#### **Global technical regulation No. 9 (Pedestrian safety) – Phase 2 of the global technical regulation**

### **Proposal for Amendment 2 (DRAFT-ver.121206)**

#### **Submitted by the chairperson of informal working group on Global technical regulation No. 9 (Pedestrian safety)-Phase 2\***

**Figure 12 Flexible lower legform impactor; Dimensions and C.G. locations of femur, knee joint and tibia (Side view)**

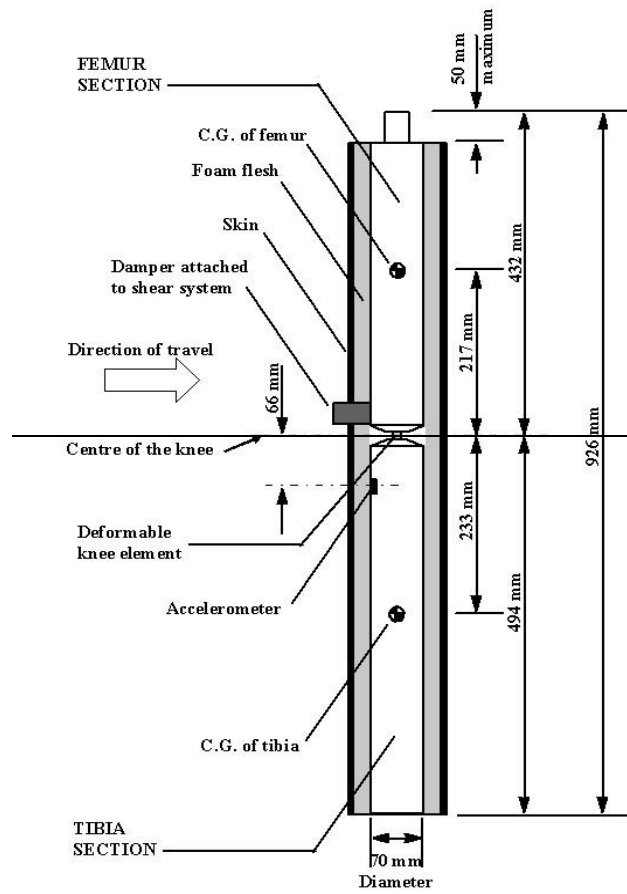
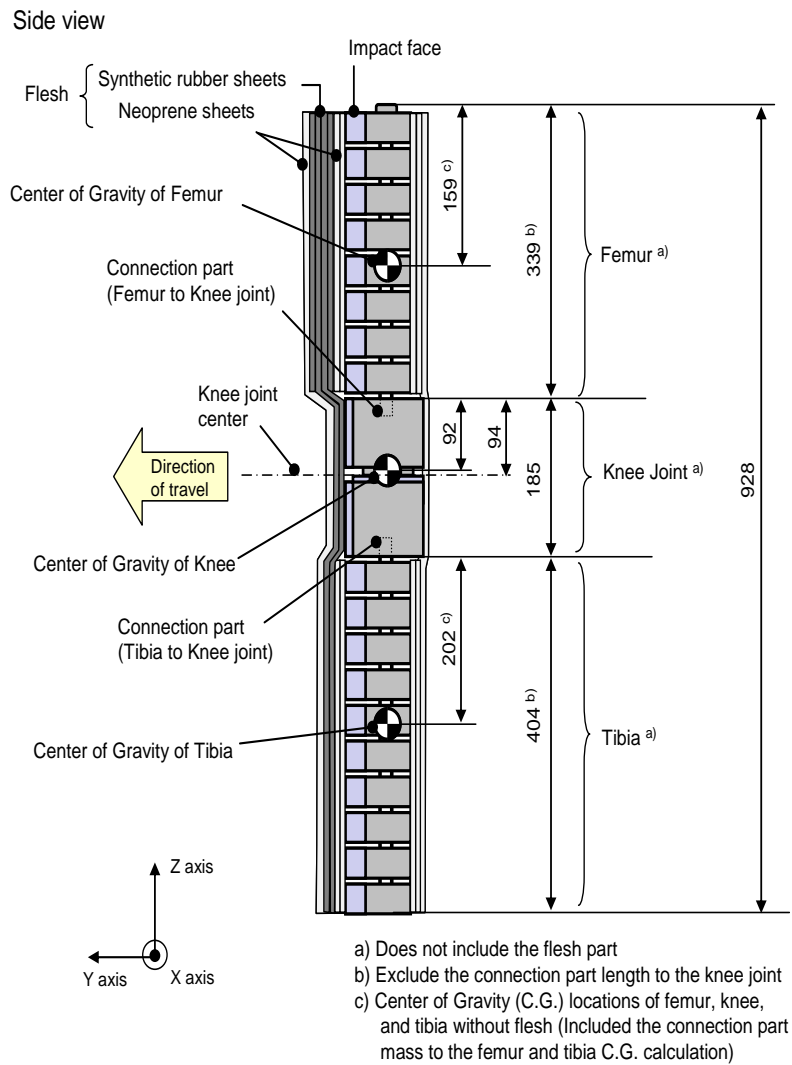
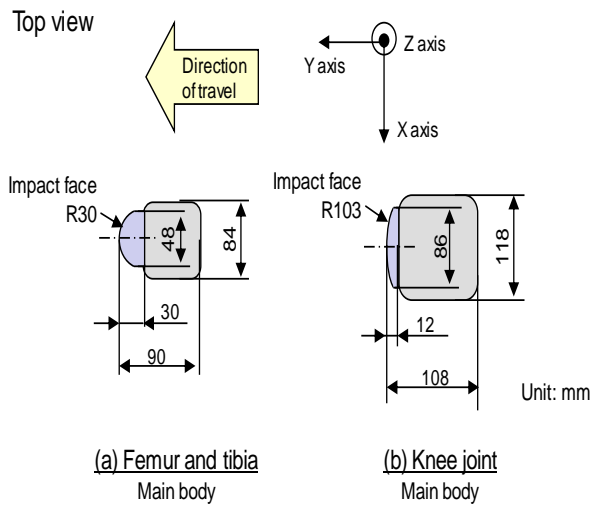
The **Flexible lower legform impactor** shall consist of flesh, flexible long bone segments (representing femur and tibia), and a knee joint as shown in Figure 12.

The overall length of the impactor shall be  $928 \pm 3$  mm, having a required mass of  $13.2 \pm 0.7$  kg including flesh. The length of the femur, knee joint, and tibia shall be  $339 \pm 2$  mm,  $185 \pm 1$  mm, and  $404 \pm 2$  mm respectively. The knee joint centre position shall be  $94 \pm 1$  mm from the top of the knee joint.

**The centre of gravity of the femur and tibia without flesh, including the connection part to the knee joint, shall be  $159 \pm 8$  mm and  $202 \pm 10$  mm respectively from the top, but not including the connection part to the knee joint, of each part as shown in Figure 12. The centre of gravity of the knee shall be  $92 \pm 5$  mm from the top of the knee joint as shown in Figure 12.**

Delete Figures 12, to read:

Insert new Figures 12 to 16, to read:

Figure 13 Flexible lower legform impactor; femur, tibia, and knee dimensions (Top view)

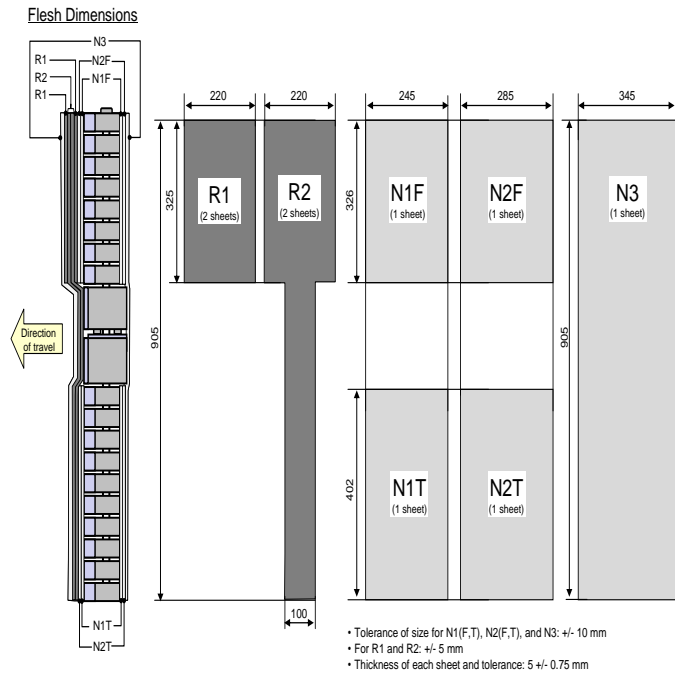
6.3.1.1.1. The cross-sectional shape perpendicular to the Z-axis of the femur and tibia main bodies shall be  $90 \pm 2$  mm in width along the Y-axis, and  $84 \pm 1$  mm in width along the X-axis as shown in Figure 13 (a). The impact face shall be  $30 \pm 1$  mm in radius,  $30 \pm 1$  mm in width along the Y-axis, and  $48 \pm 1$  mm in width along the X-axis as shown in Figure 13 (a).

- 6.3.1.1.2. **The cross-sectional shape perpendicular to the Z-axis of the knee joint shall be  $108 \pm 2$  mm in width along the Y-axis, and  $118 \pm 1$  mm in width along the X-axis as shown in Figure 13 (b). The impact face shall be  $103 \pm 1$  mm in radius,  $12 \pm 1$  mm in width along the Y-axis, and  $86 \pm 1$  mm in width along the X axis as shown in Figure 13 (b).**

Figure 14 Flexible lower legform impactor; flesh dimensions

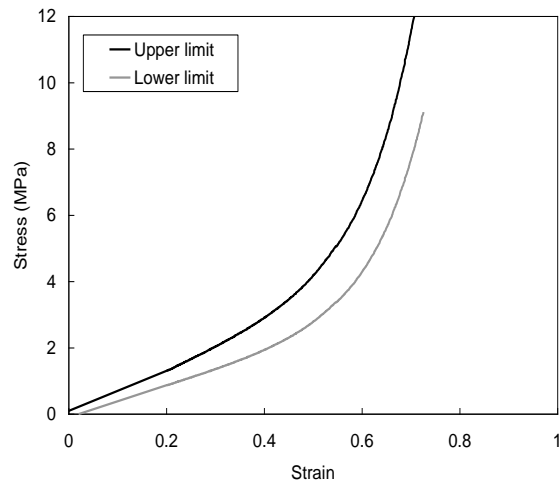
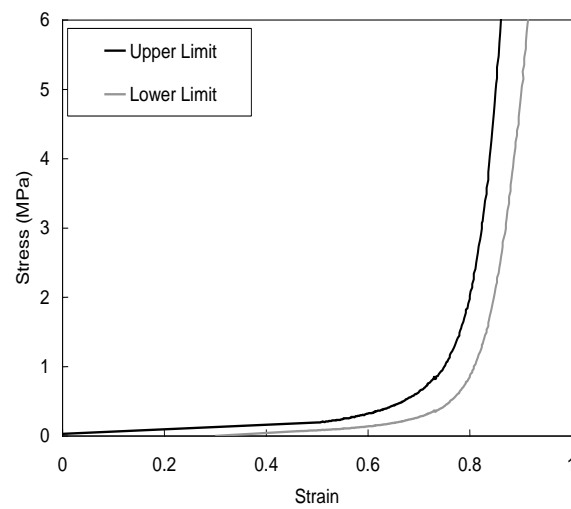
- 6.3.1.1.4. **For each test, the impactor (femur, knee joint, and tibia) shall be covered by flesh composed of synthetic rubber sheets (R1, R2) and neoprene sheets (N1F, N2F, N1T, N2T, N3) as shown in Figure 14. The sheets are required to have a compression characteristic as shown in Figure 15. The compression characteristic shall be checked using the same batch of sheets as those used for the impactor flesh. The size of the sheets shall be within the requirements described in Figure 15.**

Figure 21 **Flexible lower legform impactor** Lower legform to bumper tests for complete vehicle in normal ride attitude (left) and for cut-body mounted on supports (right) (see paragraph 7.1.1.3.) "

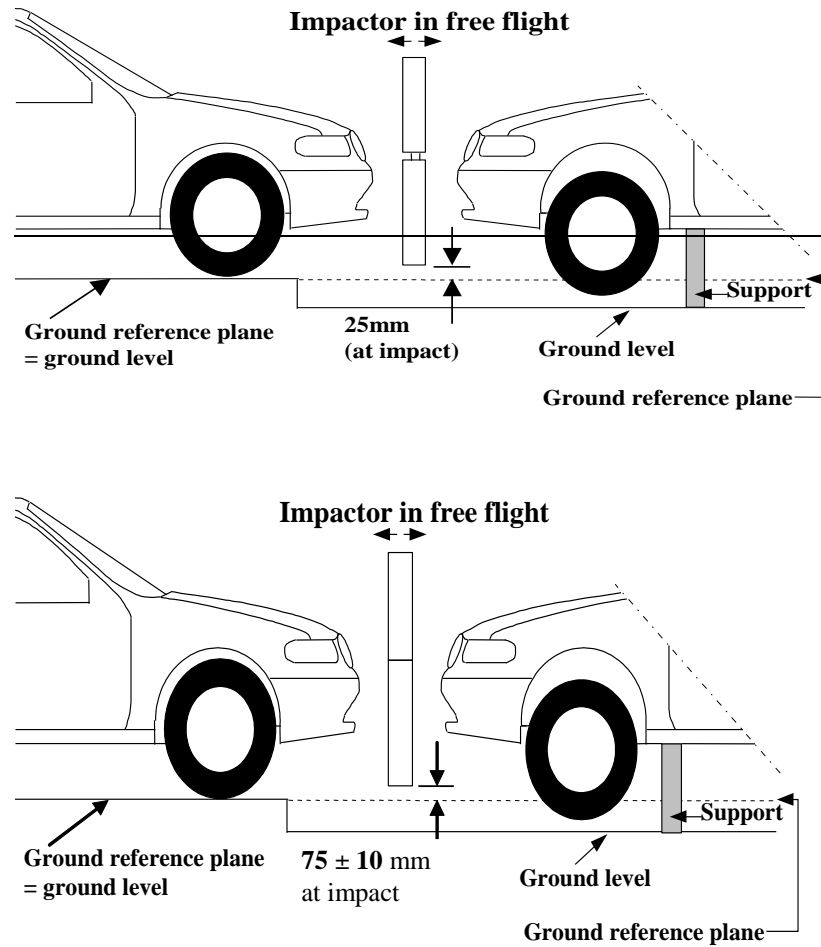
7.1.1.3. **The bottom of the impactor shall be at 75 mm above ground reference plane at the time of first contact with the bumper (see Figure 21), with a  $\pm 10$  mm tolerance. When setting the height of the propulsion system, an allowance must be made for the influence of gravity during the period of free flight of the impactor.**

Figures 17(former), renumber as Figure 21 and amend to read:

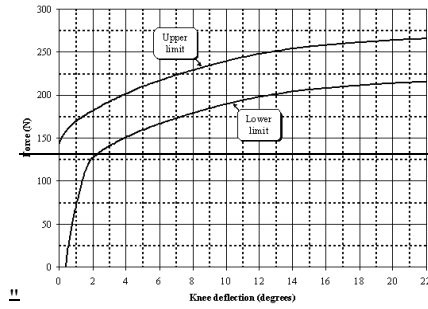
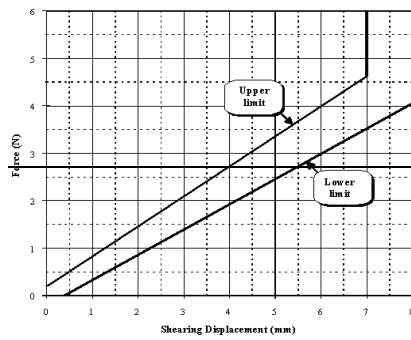
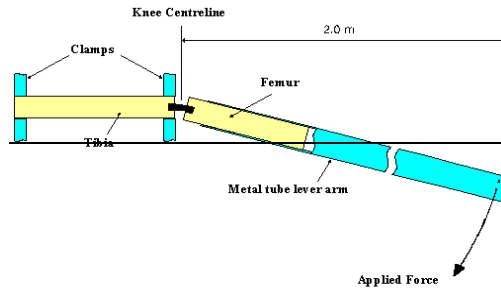
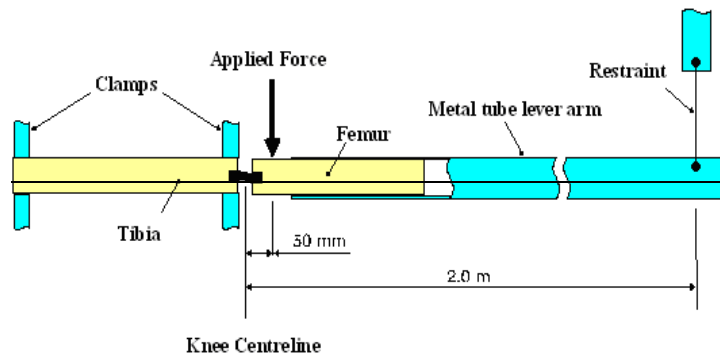
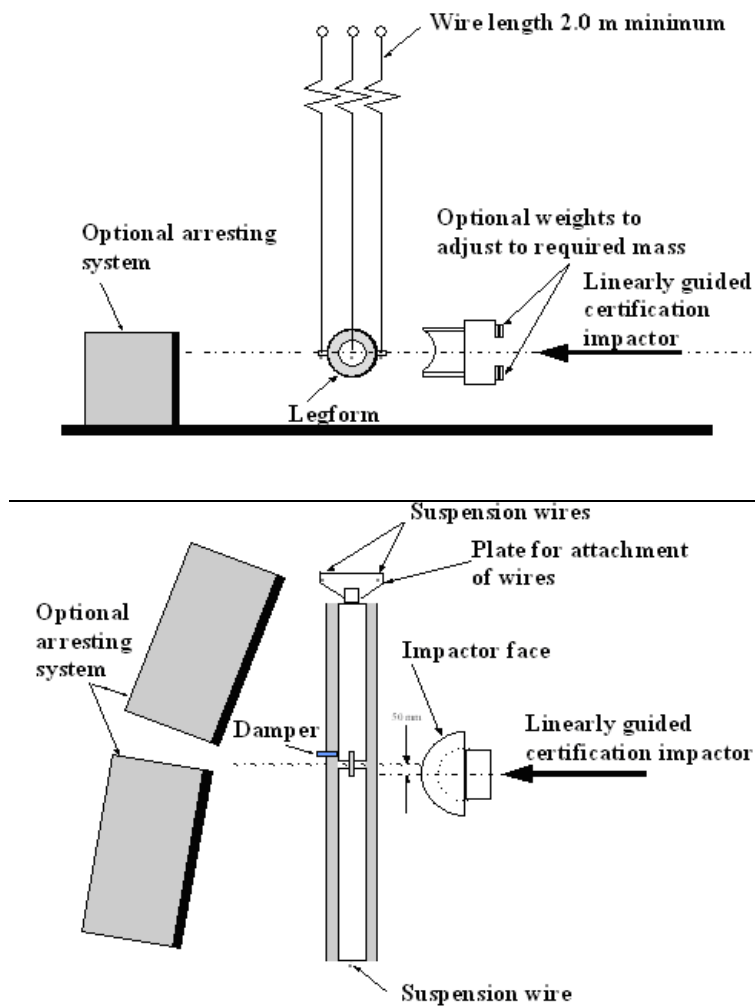
Delete Figures 18 to Figure 21, to read:

Figure 22 Flexible lower legform impactor requirement corridor of femur and tibia in static certification test (see paragraph 8.1.1.2.)

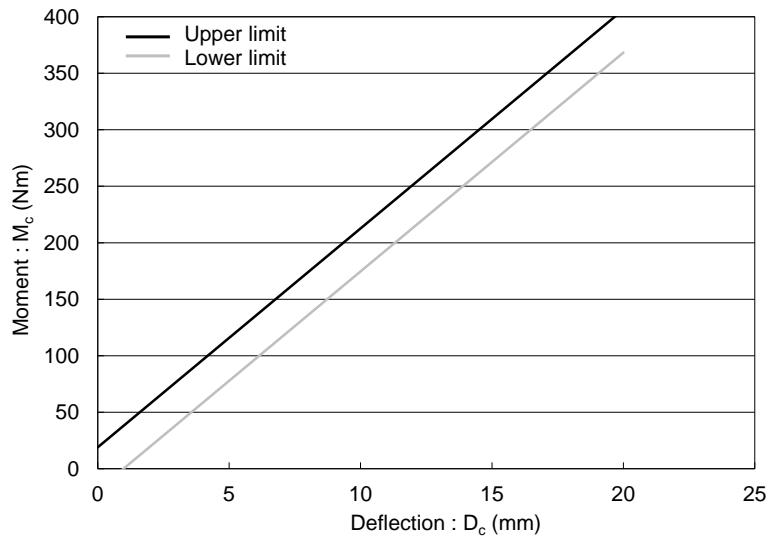
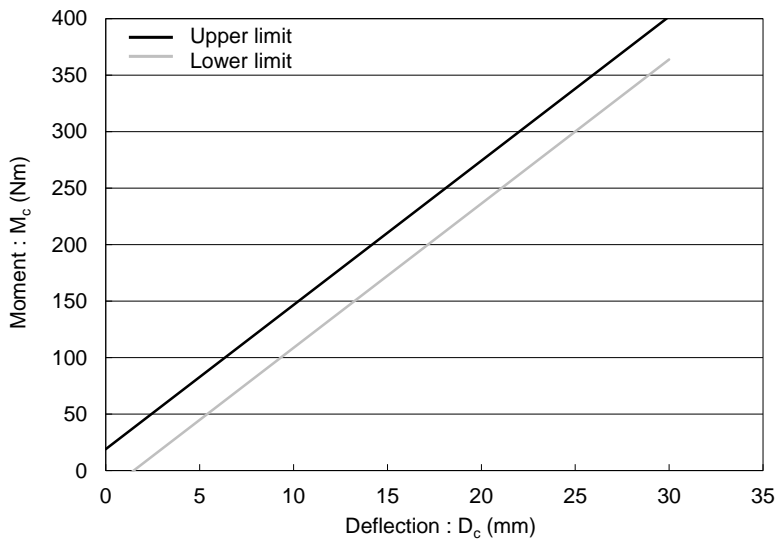
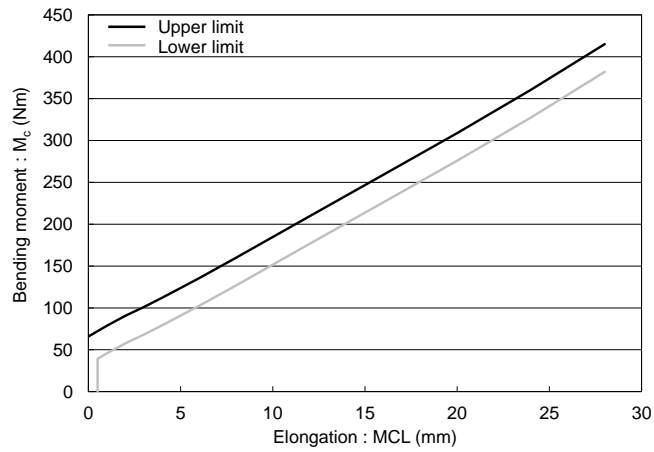
8.1.1.2. When the femur and tibia of the impactor are loaded in bending in accordance with paragraph 8.1.1.4., the applied moment and generated deflection at the centre of the femur and tibia ( $M_c$  and  $D_c$ ) shall be within the corridors shown in Figure 22.

**Figure 23 Flexible lower legform impactor requirement corridors for knee joint in static certification test (see paragraph 8.1.1.3.)**

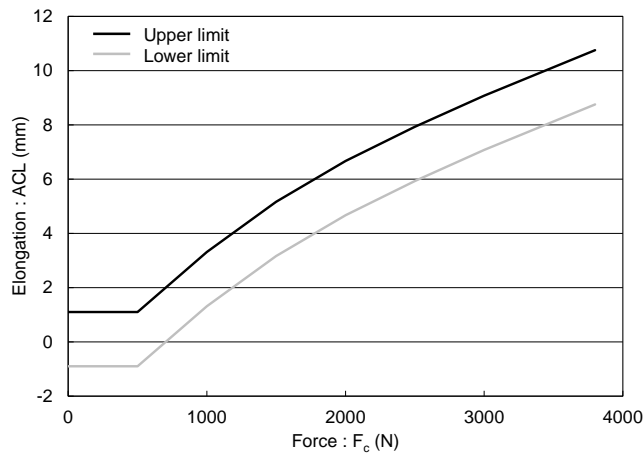
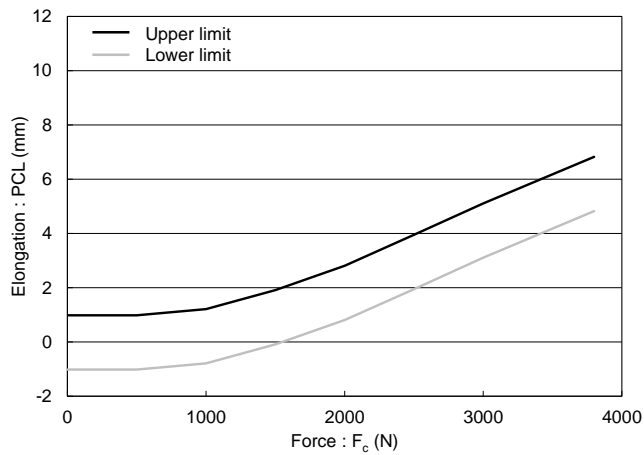
8.1.1.3. When the knee joint of the impactor is loaded in bending in accordance with paragraph 8.1.1.5., the MCL, ACL, and PCL elongations and applied bending moment or force at the centre of the knee joint ( $M_c$  or  $F_c$ ) shall be within the corridors shown in Figure 23.

**Figure 24 Flexible lower legform impactor test set-up for femur in static certification tests**

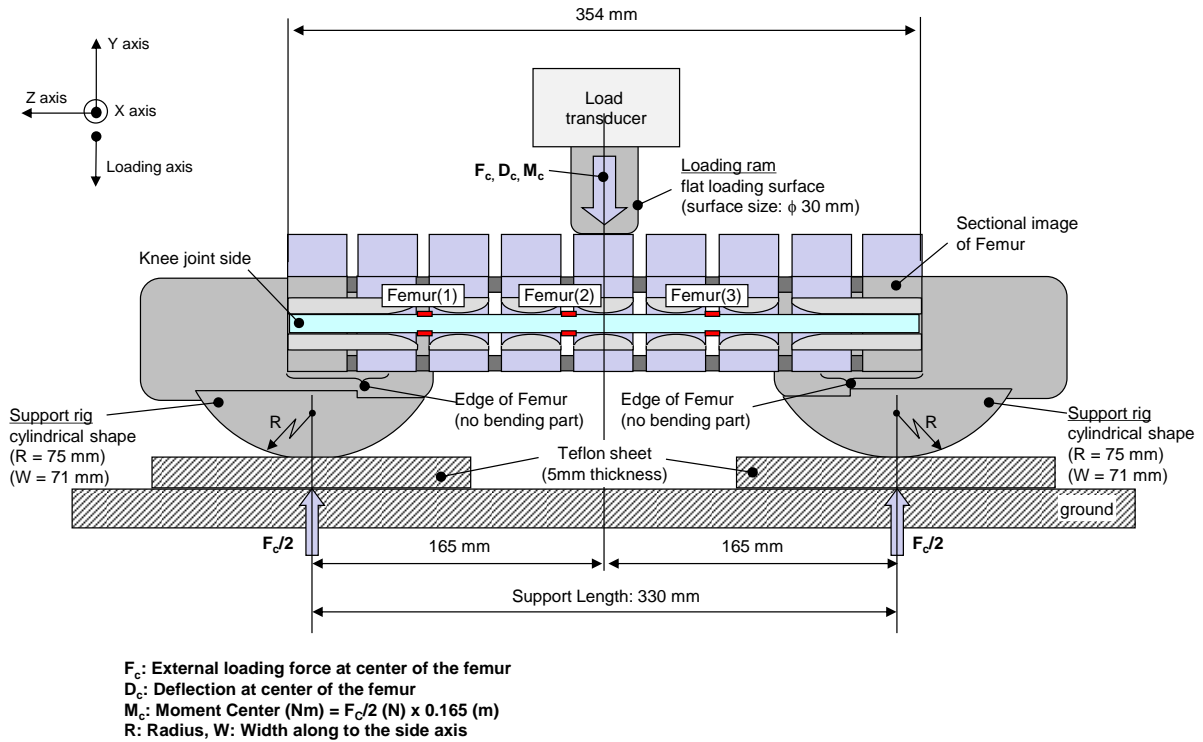
- 8.1.1.4. **The edges of the femur and tibia, not bending parts, shall be mounted to the support rig firmly as shown in Figure 24 and Figure 25. The Y-axis of the impactor shall be parallel to the loading axis within  $180 \pm 2^\circ$  tolerance. In order to avoid friction errors, roller plates shall be set underneath the support rigs.**

**Figure 26 Flexible lower legform impactor test set-up for knee joint in static certification test**

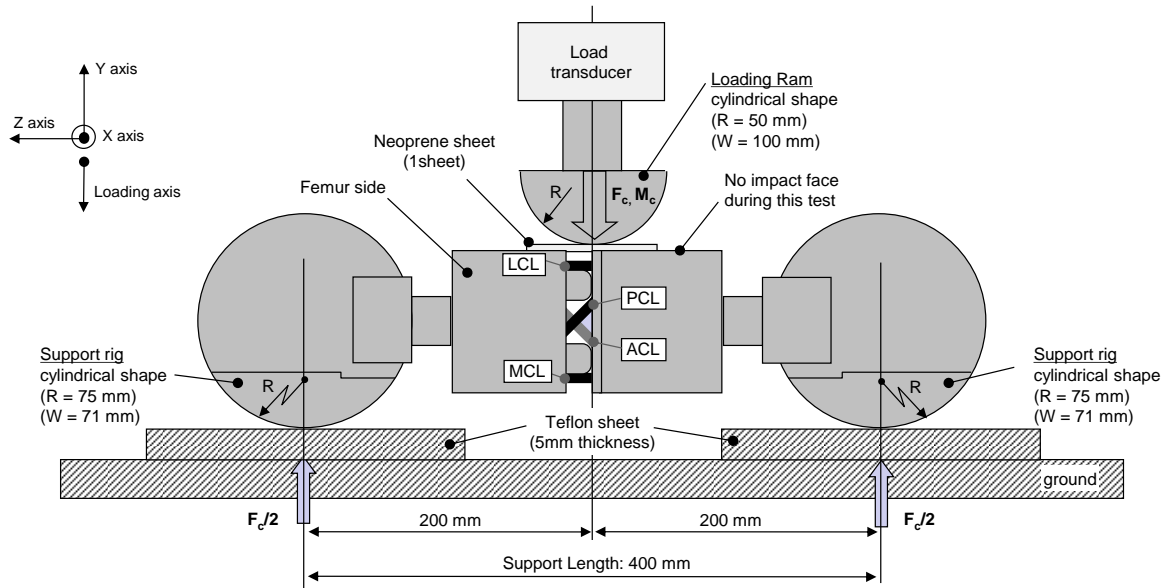
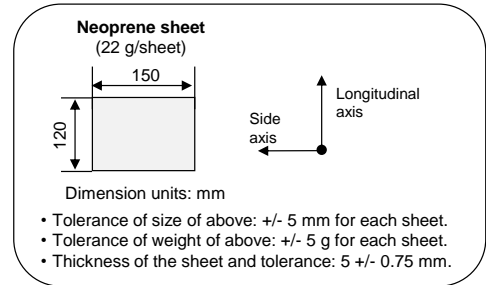
- 8.1.1.5. **The edges of the knee joint, not bending parts, shall be mounted to the support rig firmly as shown in Figure 26. The Y-axis of the impactor shall be parallel to the loading axis within  $180 \pm 2^\circ$ . In order to avoid friction errors, roller plates shall be set underneath the support rigs. To avoid impactor damage, a neoprene sheet shall be set underneath the loading ram and the impactor face of the knee joint which is described in the Figure 13 shall be removed. The neoprene sheet used in this test shall have compression characteristics as shown in Figure 15.**

**Figure 27 Flexible lower legform impactor test set-up for dynamic lower legform impactor certification test, pendulum type (see paragraph 8.1.2.4.)**

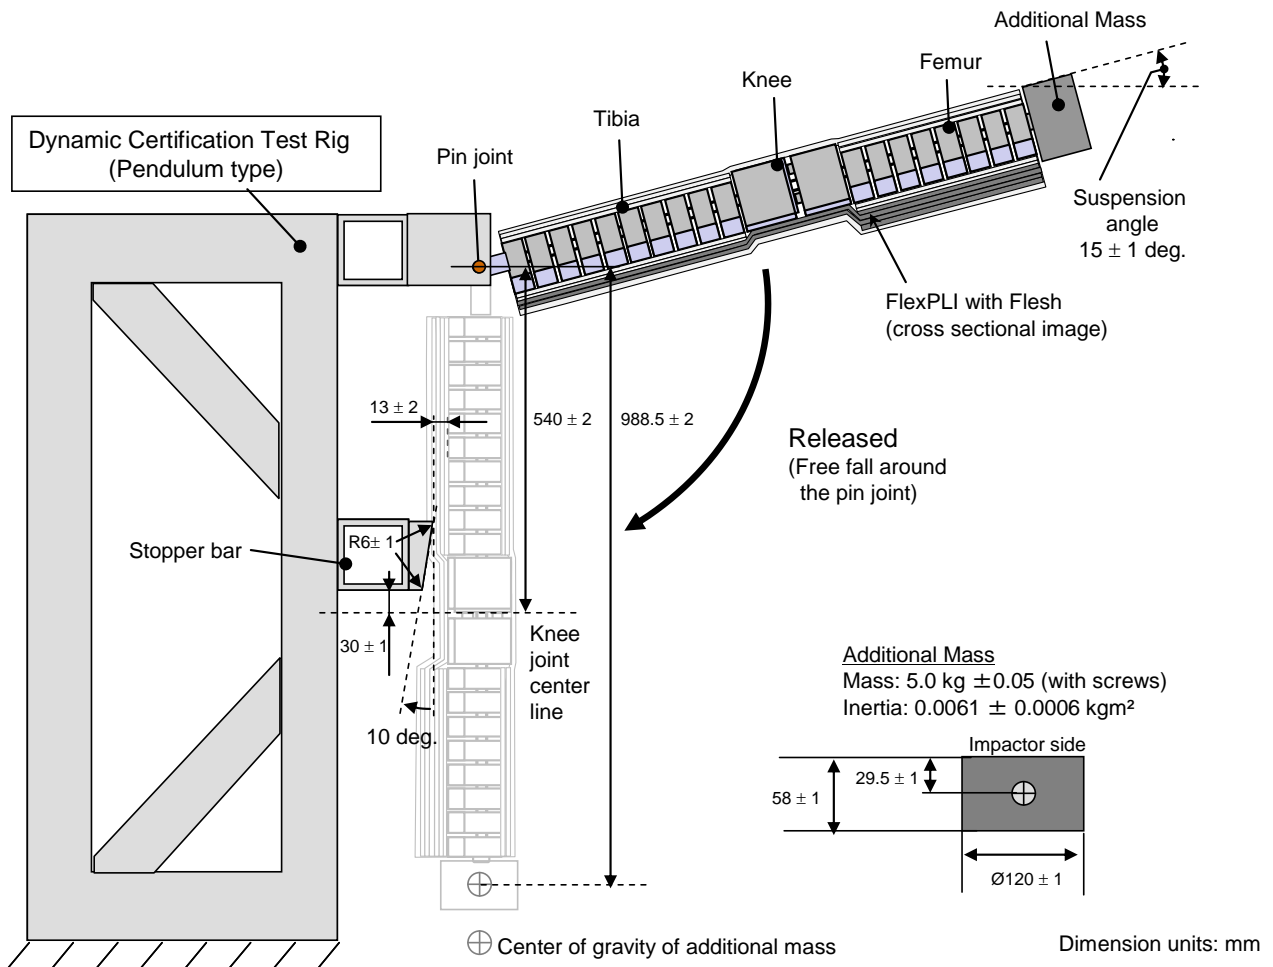
- 8.1.2.4.1. **The Flexible lower legform impactor, including flesh, shall be suspended from the dynamic certification test rig  $15 \pm 1^\circ$  upward from the horizontal as shown in Figure 27. The impactor shall be released from the suspended position, whereupon the impactor falls freely against the pin joint of the test rig as shown in Figure 27.**

- 8.1.2.4.2. **The knee joint centre of the impactor shall be  $30 \pm 1$  mm below the bottom line of the stopper bar, and the tibia impact face without flesh shall be located  $13 \pm 2$  mm from the front upper edge of the stopper bar when the impactor is hanging freely as shown in Figure 27.**
